Interactive comment on “The effect of northern forest expansion on evapotranspiration overrides that of a possible physiological water saving response to rising CO₂: Interpretations of movement in Budyko Space” by Fernando Jaramillo et al.

Response to Reviewer Nr. 1

Supplementary Figure for Budyko space- both periods

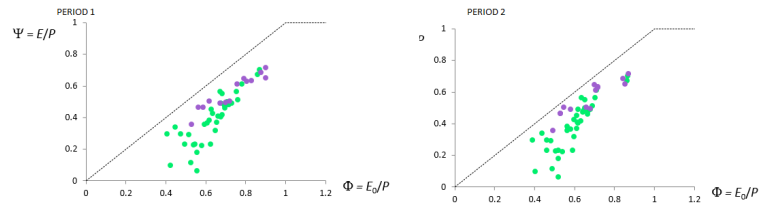
Reviewer 9. Figure 3: Can you include a separate Budyko plot for the early and late periods? That would give the reader a general, more intuitive sense of how the watersheds moved in the Budyko space.

Response 9: We will include these figures in the Supplementary information. Please see them below. We thank the Reviewer for this suggestion since with these figures show why movements in Budyko space for a large set of basins are difficult to differentiate without the use of wind-rose type plots of Fig. 4.
